TECHNICAL BULLETIN

429-17-50
20 April 2017

MODEL AFFECTED: 429

SUBJECT: FLEXIBLE STATIC DISCHARGERS,
INTRODUCTION OF.

Figure 1 – Static Discharger Locations

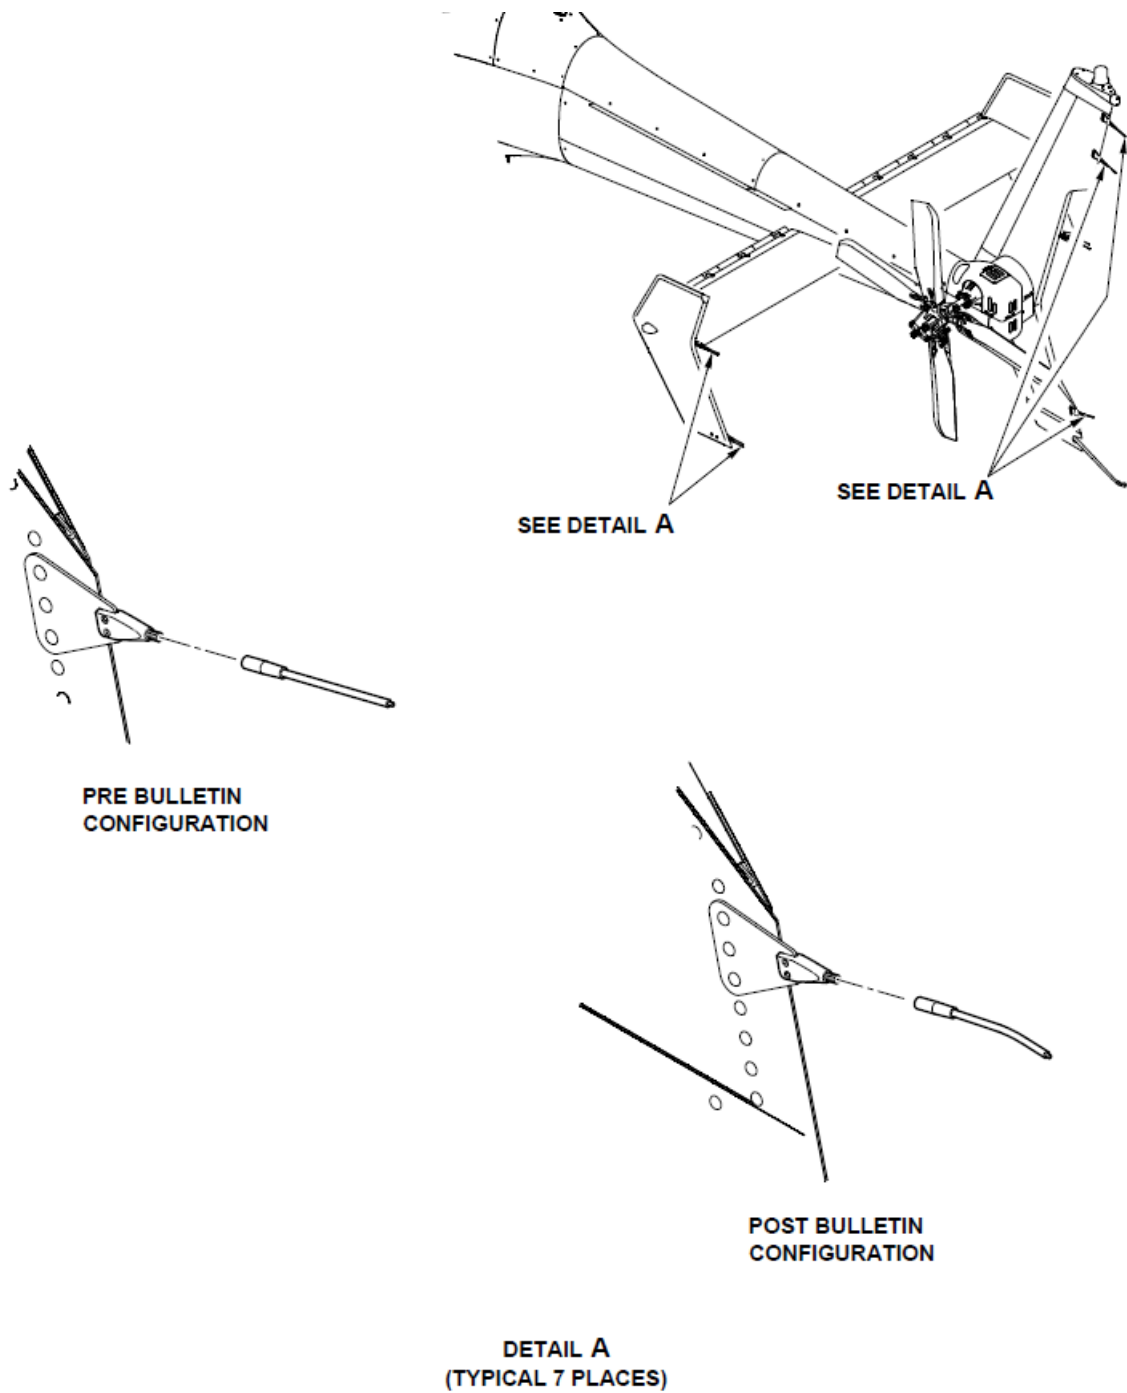
This Technical Bulletin allows the replacement of the current rigid type static dischargers located on the auxiliary and vertical fins with the flexible type static dischargers.

2. Locate the static dischargers. (Detail A, Figure 1)
3. Loosen and remove the rigid type static dischargers from their mount.
4. Install the new flexible dischargers D90-316 on the mounts. Tighten the dischargers.
5. Make an entry in the helicopter logbook and historical service records indicating compliance with this Technical Bulletin.
